<b>Docket Number:</b>	18-IRP-01
<b>Project Title:</b>	Integrated Resource Plan
<b>TN #:</b>	228244
<b>Document Title:</b>	Staff Paper - Review of Vernon Public Utilities 2018 Integrated Resource Plan
<b>Description:</b>	N/A
<b>Filer:</b>	Harinder Kaur
<b>Organization:</b>	California Energy Commission
<b>Submitter Role:</b>	Commission Staff
<b>Submission Date:</b>	5/13/2019 4:26:40 PM
<b>Docketed Date:</b>	5/13/2019

# **Review of Vernon Public Utilities 2018 Integrated Resource Plan**

May 2019 | CEC-200-2019-006

**Figure 1: Vernon and Energy Commission Energy Demand Forecasts 2018–2030 (GWh)**

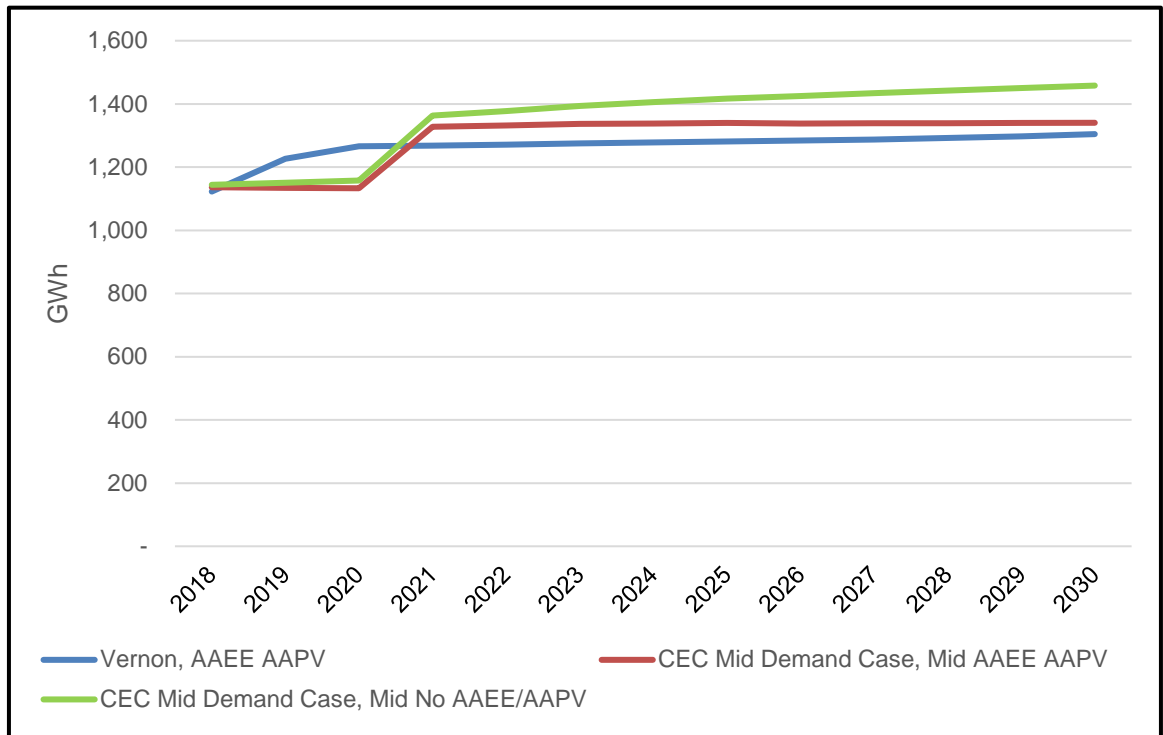
As shown in **Figure 1**, Vernon forecasts retail sales to increase 1.3 percent annually to 1,250 GWh in 2030. Forecasts through 2020 are higher than the Energy Commission’s forecast as Vernon anticipates large customer load additions in this period. By 2021, Vernon’s forecast follows the trend line of the Energy Commission’s demand forecast.

**Figure 2: Vernon and Energy Commission Peak Forecasts 2018–2030 (MW)**

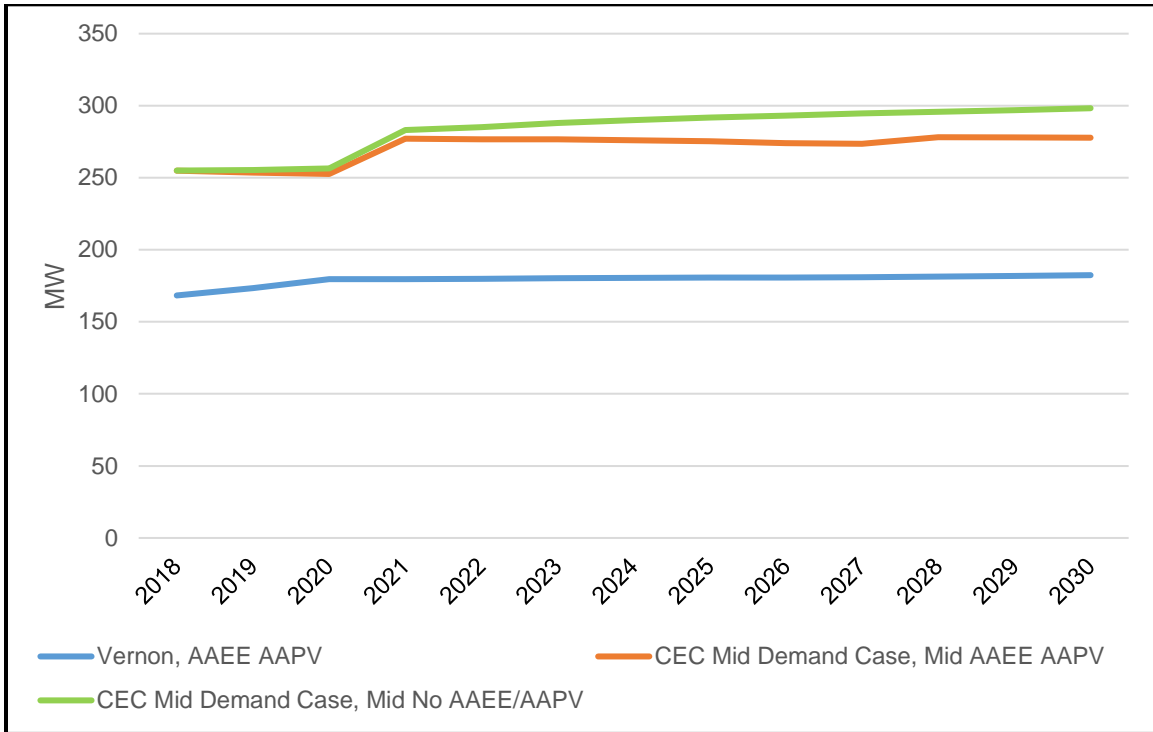
In **Figure 2**, Vernon forecasts a significantly lower peak demand in each year, by about 70 MW, compared to the Energy Commission. Vernon’s forecasts ranges from 199 MW in 2019 to 210 MW in 2030, while the Energy Commission’s forecast ranges from 255 MW in 2019 to 278 MW in 2030 (AAEE/AAPV). Differences between the models specifications, data, and assumptions can make it difficult to compare the long-term demand forecasts developed by Vernon to the Energy Commission’s forecasts.
